Memorandum

To: Salt Lake City Planning Commission
From: Brooke Olson, Principal Planner, brooke.olson@slcgov.com, 801-535-7118
Date: May 22, 2024
Re: PLNPCM2021-00698 Planned Development
144 S Apartments

Modification Request: Planned Development

PROPERTY ADDRESS: 144 S 500 E
PARCEL ID: 16-06-206-036
MASTER PLAN: [Central Community Master Plan](#)
ZONINGDISTRICT: [R-MU Residential Mixed Use](#)

Approved South Building Elevation

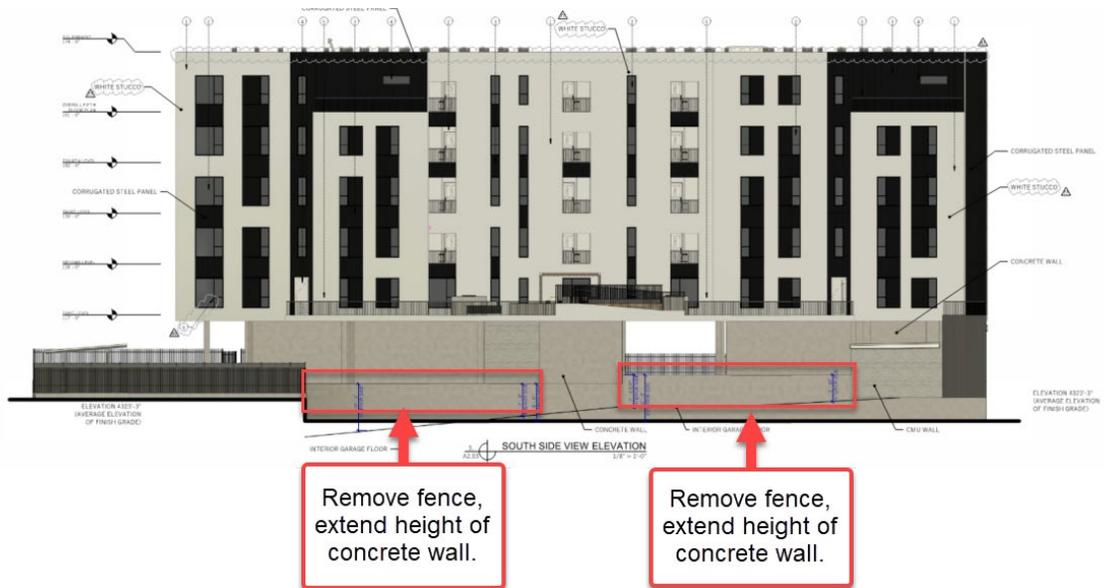
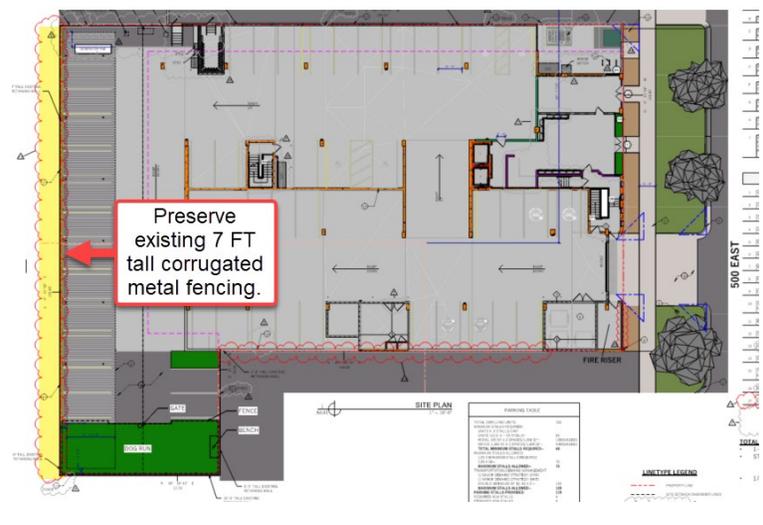
Remove the privacy fencing along the south property line and extend the height of the parking structure concrete wall. The applicant has indicated the modification is necessary since the proposed parking structure wall height provides sufficient screening between the parking area and the adjacent properties to the south.

As shown on the proposed building elevation, the interior wall height of the south parking structure wall varies from approximately 6 FT to 10 FT and the exterior wall height varies from 8 FT to 10 FT. Staff is of the opinion the proposed modification is minimal, and meets applicable Planned Development standards as the wall will provide sufficient screening between the parking area and adjacent properties to the south. Staff recommends approval of this modification.

Approved Site Plan

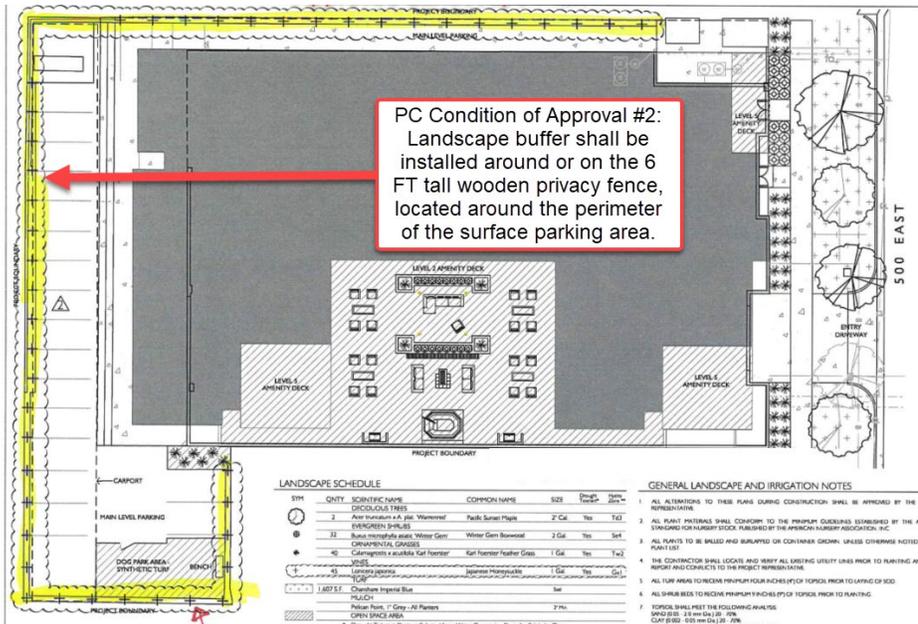
Remove the approved 6 FT tall wooden privacy fence required by the Planning Commission from the west property line and preserve the existing 7 FT 2 IN tall corrugated metal fencing on the west property line. The applicant has indicated they would like to preserve the corrugated metal fencing because it adds a unique architectural feature to the property.

In addition, 21A.40.120.E.1. indicates the fence height in residential zoning districts is limited to 6 FT behind the primary façade of the building. Staff is of the opinion the existing fencing is not appropriate for a residential use and retention of the fence is inconsistent with Planned Development Standards 21A.55.050.C Design and Compatibility:

Since the existing fence does not meet the Zoning Ordinance standards, or the applicable Planned Development standards, staff recommends denial of this modification.

Approved Landscape Plan

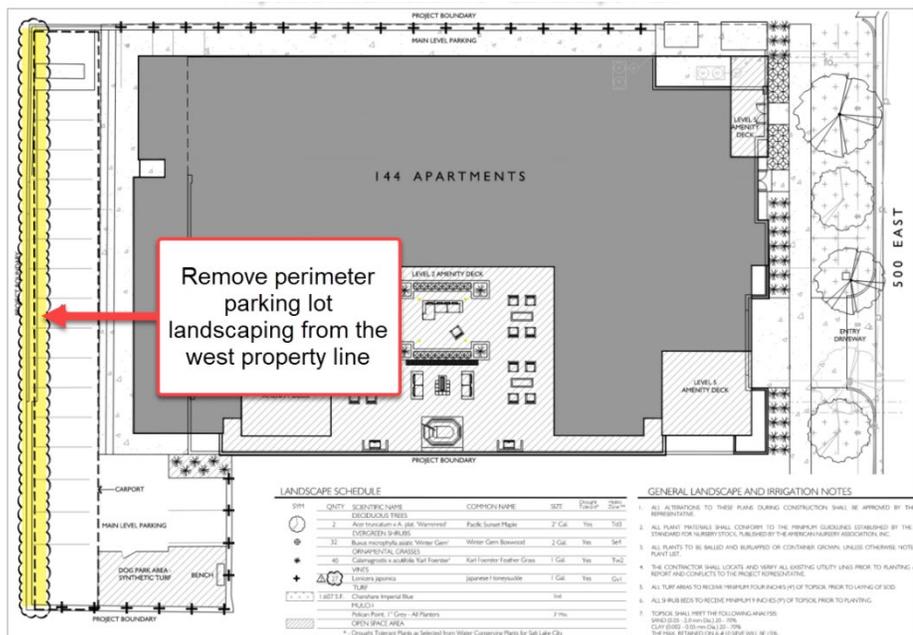
The applicant has indicated they are requesting the modification as they do not wish to cover the fence and that any plantings would be mostly not be seen and have little daylight. The applicant further indicated the retaining wall along the fence line could potentially be compromised by water required for the plantings.

In 2021, when the Planning Commission initially reviewed the Planned Development proposal, one of the modifications the applicant requested was removal of the perimeter parking lot landscaping requirement (7 FT in width protected by 6 IN curb) around the surface parking area. The modification was approved by the Planning Commission, subject to the following condition:

Per the Planning Commission's discussion, the condition was intended to provide landscaping and greenery around the perimeter of the surface parking area but allow flexibility in terms of landscaping width and curb. To meet the condition, the applicant initially proposed installing a narrow landscape bed planted with Japanese Honeysuckle climbing vine as highlighted in the approved landscape plan above. The vine is a drought tolerant species which requires full sun to partial sun and minimal water once established.

The approved perimeter landscaping along the west property line provides numerous environmental and aesthetic benefits, enhances the project, and helps lessen impacts created by the proposed development. Removal of the landscaping from the west property line would significantly reduce the already limited living vegetation provided on site. While the applicant has indicated lack of sunlight due to the carport and the structural integrity of the retaining wall are concerns, various small, drought tolerant plant species can tolerate full shade and very minimal water. The City's [Plant List & Hydrozone Schedule](#) in addition to the [Conservation Garden Park Plant Database](#) are useful resources for identifying drought tolerant plant species with specific environmental needs. Additionally, drip irrigation systems can be installed to apply small amounts of water directly to the root zones of the plants. Therefore, Planning staff recommends denial of this modification.
